Type Coffee Vending Machine	Model 9100 IN	T.I. NO 06 - 2017	
Serial Number 72412398	Subject NEW MIXER ASSEMBLY	ISSUED	Action
		FOR (X)	Information X

TECHNICAL INFORMATION JDE

1.

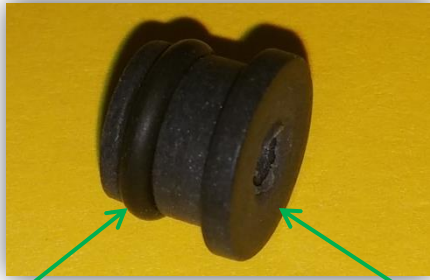
New solution: bush seal + gasket OR

Pre-modification solution: V-Ring

3.

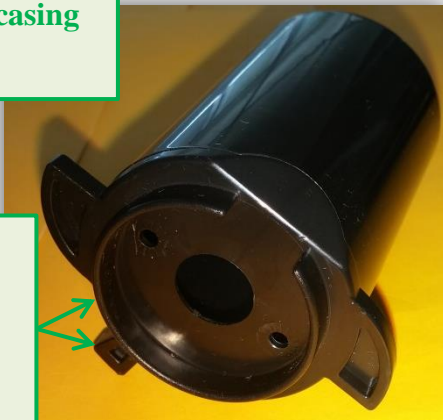
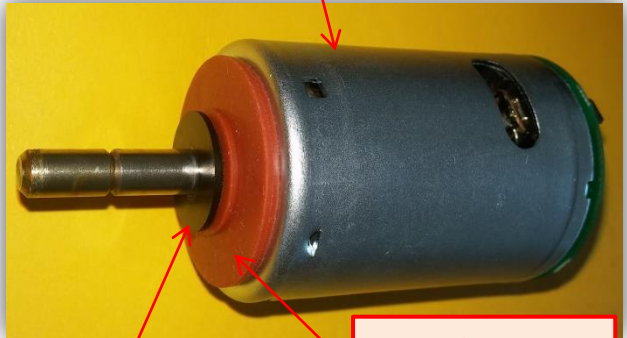
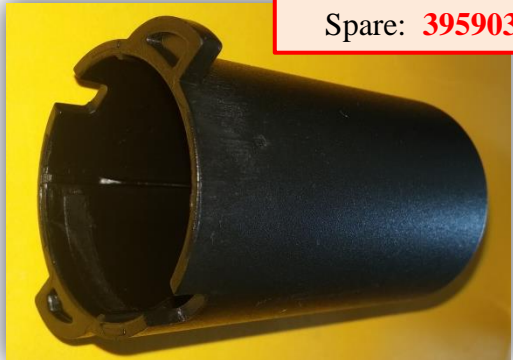
New solution

Crown and sprocket added to improve the fixing to the Flange

Pre-modification solution

4.

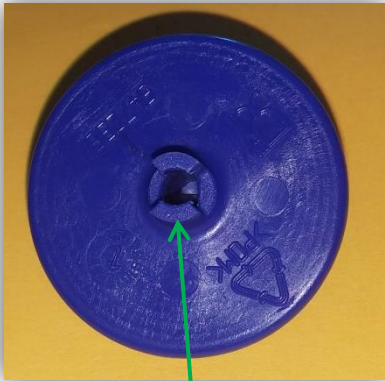
New mixer fan

Whisk shaft D. **4 mm**

Pre-modification mixer fan

Whisk shaft D. **6 mm**
